North – South Commuter Railway (NSCR) Project (Malolos – Tutuban) Package CP01: Elevated Structures, 7 Stations and Depot			
ITEM NO.	REFERENCE CLAUSE/ SECTION	CLARIFICATION REQUEST	RESPONSE
<i>Volume IA, Part 1 – Bill of Quantities</i>			
1		<p>Regarding the BOQ, some of the items indicated in PDF and EXCEL file BOQ differ in their quantities.</p> <p>CP01 - Vol IA - BOQ - Excel Files_May 2018: . . . 05 BOQ Without Cost CP01 Bill 3 Stations REV. 21-12.xlsx</p> <p>PDF file (in "For BID - NSCR - CP01"): . . . 2) NSCR BD CP01-Vol IA-BOQ_May 2018.pdf"</p> <p>May we assume quantities in the PDF file "2) NSCR BD CP01-Vol IA-BOQ_May 2018.pdf" to be correct?</p>	Yes, please consider the PDF file correct.
2	BOQ Item No. 405(16)	<p><u>Reference:</u> <i>Blinding Concrete for Garbage Shed for Light Repair Shop</i></p> <p>BOQ Item No. 405(16) for Garbage Shed for LRS is included in BILL OF QUANTITIES in Vol. IA of V in PDF, but not included in Excel File. Please verify which will prevail.</p>	The PDF file of the BOQ will prevail.

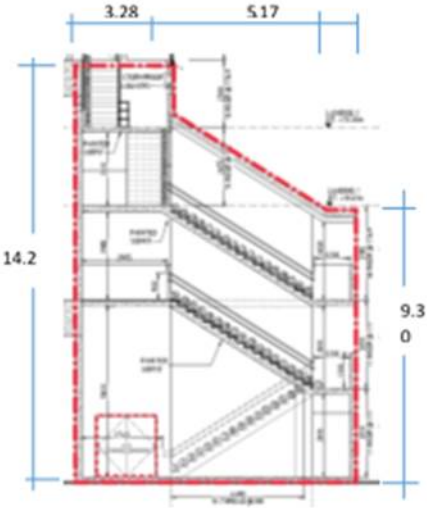
69	Pages CP01-B4-312 and CP01-B4-315	At Concourse Level First Aid Room, floor finish differs as follows: CP01-B4-312 ··· 600 x 600 x 6mm thk. Vitrified Ceramic Floor Tile	Please use 600 x 600 x 9mm thk.(min) Vitrified floor tile.

North – South Commuter Railway (NSCR) Project (Malolos – Tutuban) Package CP01: Elevated Structures, 7 Stations and Depot			
ITEM NO.	REFERENCE CLAUSE/ SECTION	CLARIFICATION REQUEST	RESPONSE
		 <p>→ L3A – W9450 x H14200 with opening area for D1</p> <p>CP01-B4-346 At Left Side Elevation</p>

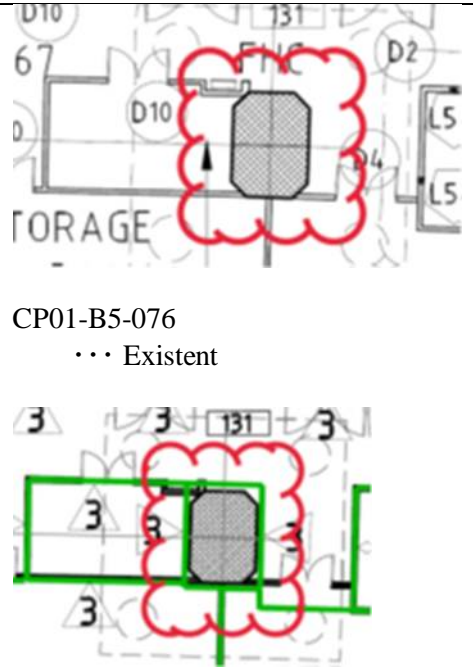
North – South Commuter Railway (NSCR) Project (Malolos – Tutuban) Package CP01: Elevated Structures, 7 Stations and Depot			
ITEM NO.	REFERENCE CLAUSE/ SECTION	CLARIFICATION REQUEST	RESPONSE
		<p>Elevation List</p> <p>D2 ⊙ H=3000 H=2100</p> <p>L1A H=1810 ⊙ H=6040</p> <p>L1B H=1810 ⊙ H=6040</p> <p>L1C H=1820 ⊙ H=6040</p> <p>L5I H=350 ⊙ H=300</p> <p>L3D H=7895 ⊙ H=7900</p> <p>D4 ⊙ W=1850 W=3050</p> <p>L2A W=1095 ⊙ W=1100</p>	
76	Page CP01-B4-321	<p>On CP01-B4-321 the width of L3B is indicated as W=3400(1995+1995), may we consider its width to be W=3990?</p> <p>Moreover, may we assume that the opening area is unnecessary for L3B?</p>	Yes, the Bidder's assumption is correct. W=3990 and opening is not necessary.
77	Pages CP01-B4-321 and CP01-B4-346	<p>On CP01-B4-321, the Elevation shown for L3A is not fitted for the Stair 3.</p> <p>May we assume its dimension to be as follows?</p> <p>L3A - W9815 x H16945</p>	Please consider the correct dimensions based on floor plan and elevation drawings.

ITEM NO.	REFERENCE CLAUSE/ SECTION	CLARIFICATION REQUEST	RESPONSE
		 <p>CP01-B4-346 At Right Side Elevation</p>

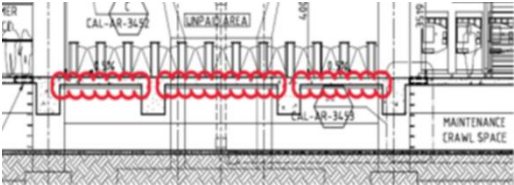
78	Pages CP01-B4-344, CP01-B4-346, and CP01-B4-385	<p>Fire Exit Stairs Roof differs as follows: CP01-B4-344,346 ... Glass Panel CP01-B4-385 ... RC Roof</p> <p>May we assume the one indicated on CP01-B4-344,346 Glass Panel to be correct?</p>	Yes, the Bidder's assumption is correct.
79	Page CP01-B4-346	<p>On CP01-B4-346, the height of L3B is indicated as H=12615, but the Stair3 height from GL to Landing 1 is H=10.61m. May we assume its height to be H=9300?</p>	Yes, the Bidder's assumption is correct, H=9300.
80	Page CP01-B4-346	<p>On CP01-B4-346 Fire Exit Stair 3, please provide the width of the Louver(H=900) at Landing 2.</p>	Louver will enclose the stairs as shown in elevations.

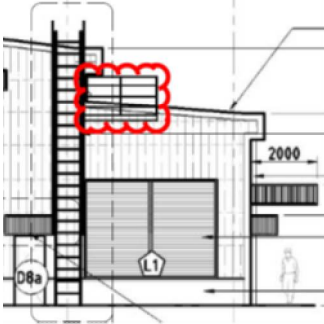
123	Page CP01-B7-137	<u>Reference:</u> <i>Gate Valve</i> Please provide details/specifications of removable cover of	Please refer to TS 100 Clause 143.3.2.

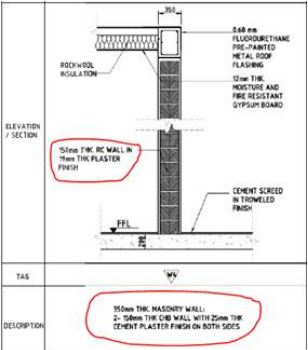
160	Pages CP01-B8-033 & CP01-B8-034	<p><u>Reference:</u> <i>Floor Finishes</i></p> <p>Please verify conflict in floor finishes for Female & Male Toilet and Male & Female Toilet and Shower Room:</p> <ul style="list-style-type: none"> - on NSCR-DWG-LRS-AR-3171 it is 600x600mm Vitrified Ceramic Tile, while - on NSCR-DWG-LRS-AR-3181 it is 300x300mm Vitrified Ceramic Tile. 	Please use 300x300mm Vitrified Ceramic Tile.
161	Pages CP01-B8-	At Male and Female Bedroom, Male and Female Locker Room	Yes, the Bidder's Assumption is correct. The Male and

North – South Commuter Railway (NSCR) Project (Malolos – Tutuban) Package CP01: Elevated Structures, 7 Stations and Depot			
ITEM NO.	REFERENCE CLAUSE/ SECTION	CLARIFICATION REQUEST	RESPONSE
	033 & CP01-B8-034	<p>floor finish differs as follows,</p> <p>CP01-B8-033 ··· FF6: 300 x 300 Vitrified Ceramic Floor Tiles</p> <p>CP01-B8-034 ··· FF5: 600 x 600 Vitrified Ceramic Floor Tiles</p> <p>May we assume the one indicated on CP01-B8-034 to be correct?</p>	Female Bedroom, Male and Female Locker Room floor finish is FF5: 600 x 600 Vitrified Ceramic Floor Tiles.
162	Pages CP01-B8-033 & CP01-B8-034	<p>At Electrical Room floor finish differs as follows,</p> <p>CP01-B8-033 ··· FF2: Self-Levelling Epoxy Paint Finish with Hardener</p> <p>CP01-B8-034 ··· FF1: Plain Cement Troweled Finish w/ Concrete Hardener</p> <p>May we assume the one indicated on CP01-B8-033 to be correct?</p>	Yes, the Bidder's assumption is correct. The Electrical Room floor finish is FF2: Self-Levelling Epoxy Paint Finish with Hardener.

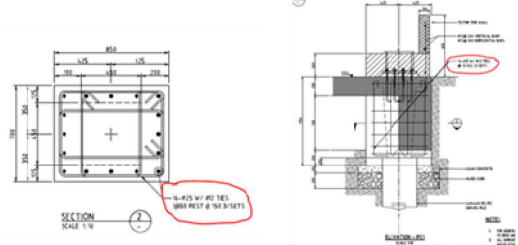
344	Page CP01-B10-145	<p>On CP01-B10-145, please identify the items below, if they are under Building Works, please provide specification and detail.</p> <div style="text-align: center;">  </div>	<p>These are Steel Cabinets W=1200xH1800xD800mm. All furniture of high quality are subject for approval of the Engineer.</p>
345	Pages CP01-B10-145 to CP01-B10-148	<p>Size and Form of W2(Window) shown on Floor Plan, Section and Elevation differ from Schedule of Windows as follows, CP01-B10-145 to 147 ... W1400 x H1350 (4-Panel Awning Window) CP01-B10-148</p>	<p>Yes, the Bidder's assumption is correct. W2 is W1400 x H1350 (4-Panel Awning Window).</p>

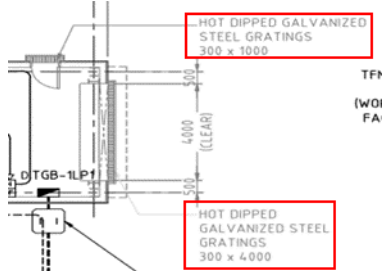
348	Pages CP01-B10-147 and CP01-B10-148	<p>Form of W5 shown on Right Side Elevation differ from Schedule of Windows as follows,</p> <p style="padding-left: 40px;">CP01-B10-147 ... 3-Panel Fixed Louver</p>	W5 on Right Side Elevation shall be read as W8. The dimension shall be W4150xH1000, 3-Panel Fixed Louver. Please refer to Section VI, 3 Drawings, Book 10 of 11, Page CP01-B10-148 for the specifications.

North – South Commuter Railway (NSCR) Project (Malolos – Tutuban) Package CP01: Elevated Structures, 7 Stations and Depot			
ITEM NO.	REFERENCE CLAUSE/ SECTION	CLARIFICATION REQUEST	RESPONSE
		<p>CP01-B10-148 ··· 5-Panel Fixed Louver May we assume CP01-B10-147 to be correct and consider 3-Panel Fixed Louver?</p>	
349	Page CP01-B10-148	<p><u>Reference:</u> <i>Masonry Paint</i></p> <p>Please verify if High-performance Urethane Coatings for Masonry Painting will be used for the wall finish of Maintenance Area. Painting is not specified in plans but has pay item in BOQ.</p>	<p>Plain Cement Plastered CHB finish is indicated as painted in Fluorourethane coating in Section VI, 3 Drawings, Book 10 of 11, Page CP01-B10-148. Please refer to BOQ preamble.</p>
350	Pages CP01-B10-147 & CP01-B10-148	<p><u>Reference:</u> <i>Window.</i></p> <p>Please check windows (W3, W4 & W5) reflected in elevation on NSCR-DWG-CMV-ST-3131: windows do not match the sizes/details shown in Schedule of Windows on NSCR-DWG-CMV-ST-3141.</p>	<p>These windows are louver windows. Please use specifications of louver at Schedule of Windows and the dimensions as follows: W3 = W4957 x H1350 W4 = W5900 x H1350 W5 = W4000 x H1000</p>
